U.S. Department of Defense

SEPTEMBER 24, 2015

Continental United States Military Housing Inspections – Southeast

Figure 13. An ungrounded light switch in a Fort Gordon family housing unit.
(Deficiency No. FGN-EL-150309-085)
Source: DoD OIG

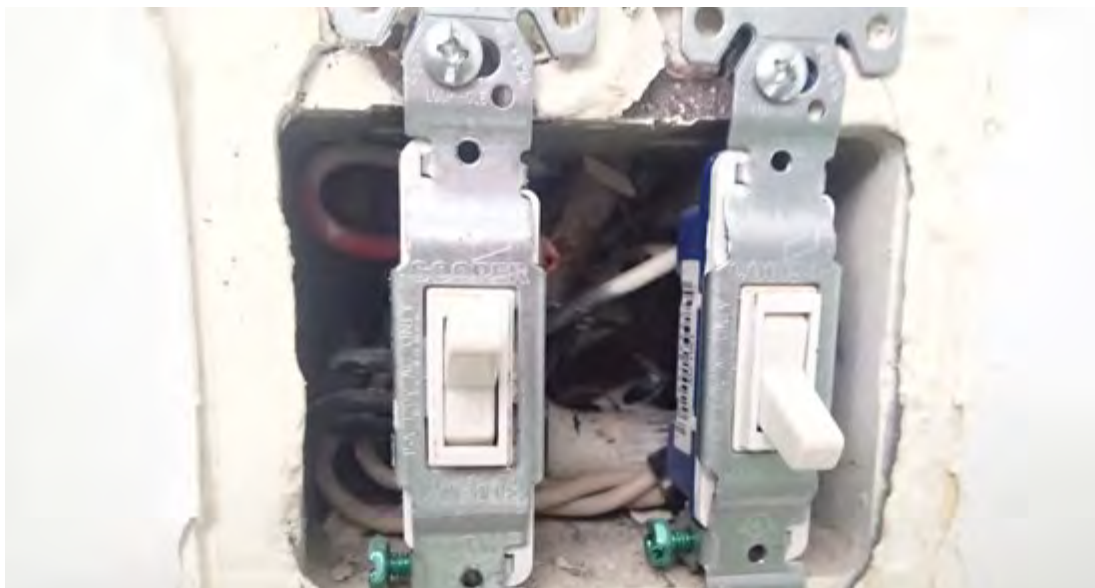
The most significant issue we found was the ground conductors on light switches (see Figure 13) were not connected throughout the homes inspected in the Gordon Terrace, McNair Terrace, and Olive Terrace neighborhoods. In the event of a short circuit to the metallic light switch body, the ground conductor would prevent an individual from being exposed to potentially lethal voltages. We also identified problems with electrical receptacles and wiring as well as the lack of GFCI-protected receptacles in the kitchen areas of a few homes inspected.
